Crystal Park Apartments

CITY OF LAS VEGAS		DATE:
INTER-OFFICE MEMORANDUM		January 22, 2018
TO: Land Development Services Department of Building & Safety		FROM: Albert Sung, P.E. Flood Control Project Engineer Department of Public Works
SUBJECT:	Drainage Study for:	COPIES TO:
	Crystal Park Apartments	VTN, Nevada
Cross Streets:	SEQ of Cheyenne Boulevard & Michael Way	EAB Investment Company
File Number:	F:\Depot\DSMemos\DS4922B.ZNAE.doc	Bart Anderson, P.E., DevCo
Parcel Number:	138-13-512-001	CCRFCD
Zoning Action:	SDR-41779 & EOT-71642	
FEMA Flood Zone	YES	NO X
Proposed Storm Drain	YES	NO X

The Drainage Study for the subject project has been reviewed and:

CRYSTAL PARK APARTMENTS
FIGURE 6: EXISTING CONDITION DRAINAGE MAP

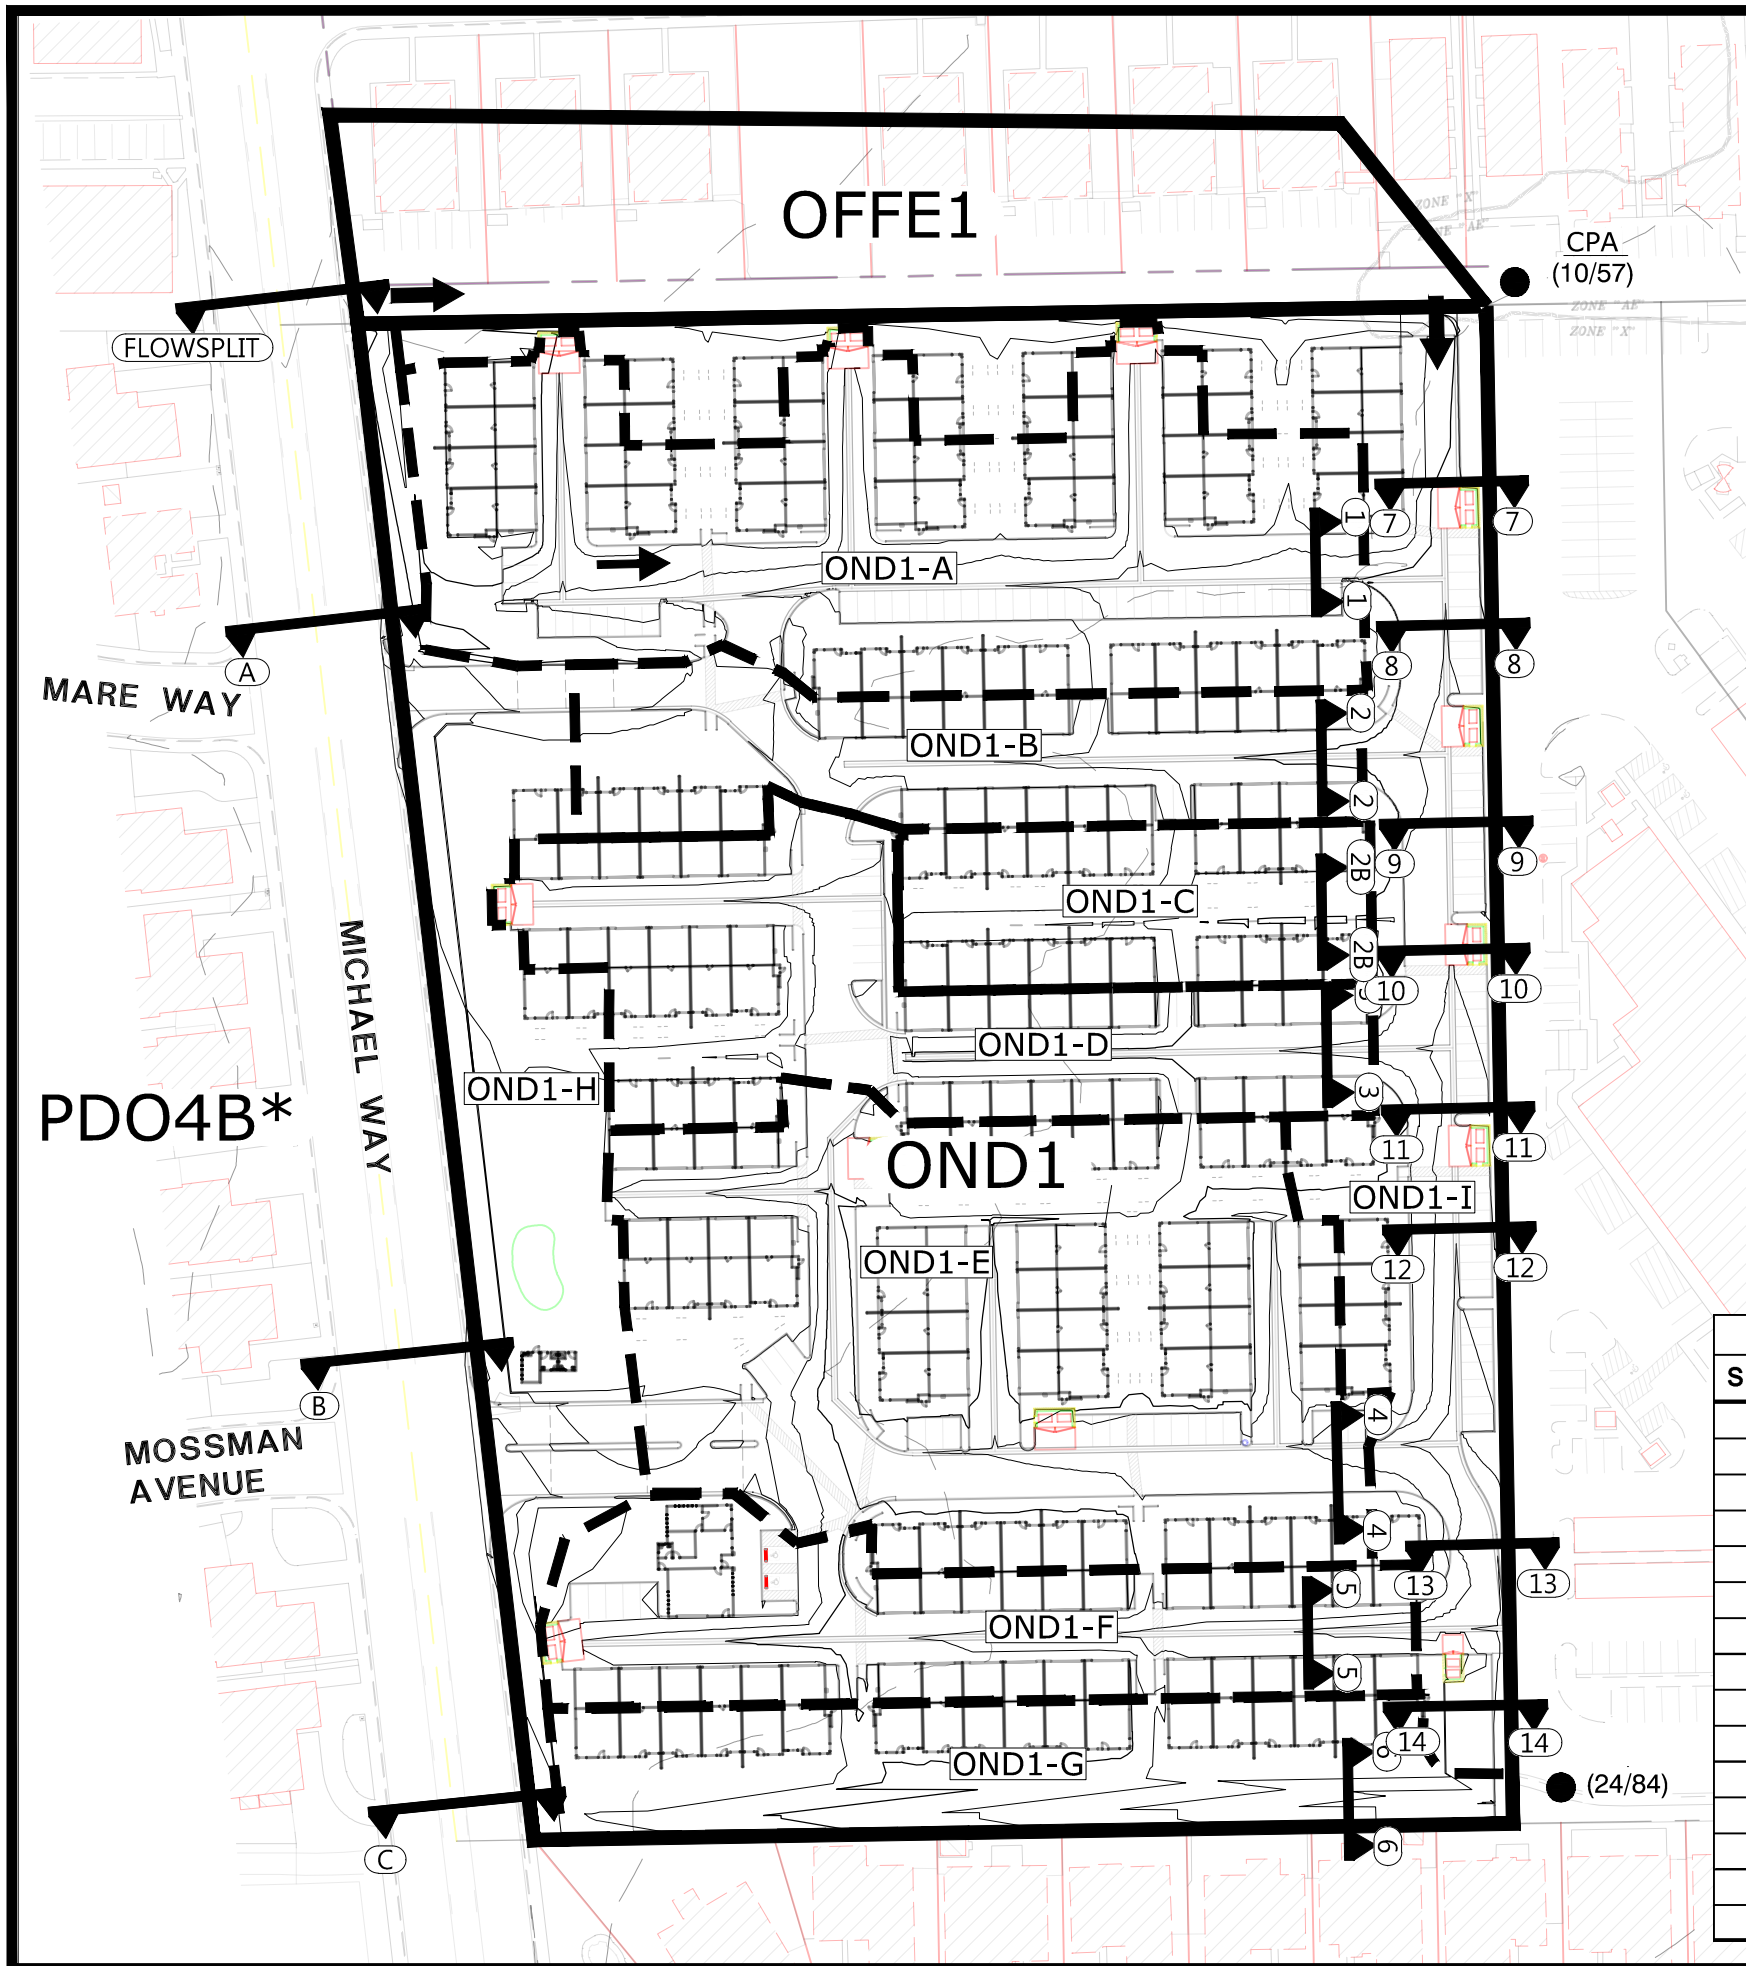
Figure 6: Existing Condition Drainage Map shows the Q_{10}/Q_{100} for “CPE4” as 21cfs/81cfs while Page 4 of the Study (Subchapter “Onsite Drainage Basin Description) shows 11cfs/24cfs. Clarify in the next submittal.

Note: It is however, the opinion of the reviewer that $Q_{10}/Q_{100}=11\text{cfs}/24\text{cfs}$ is more reasonable because in the existing condition the flow at the northeast corner of the site (“CPA”) do sheet flow into the adjacent commercial lot. There is no berm or channel to direct the flow at the northeast corner to go south.

RESPONSE: The existing condition HEC-1 model and *Figure 6: Existing Condition Drainage Map* have been revised to show 24cfs/11cfs at CPE4. Figures have been included in Appendix A. The revised HEC-1 model has been included in Appendix B.
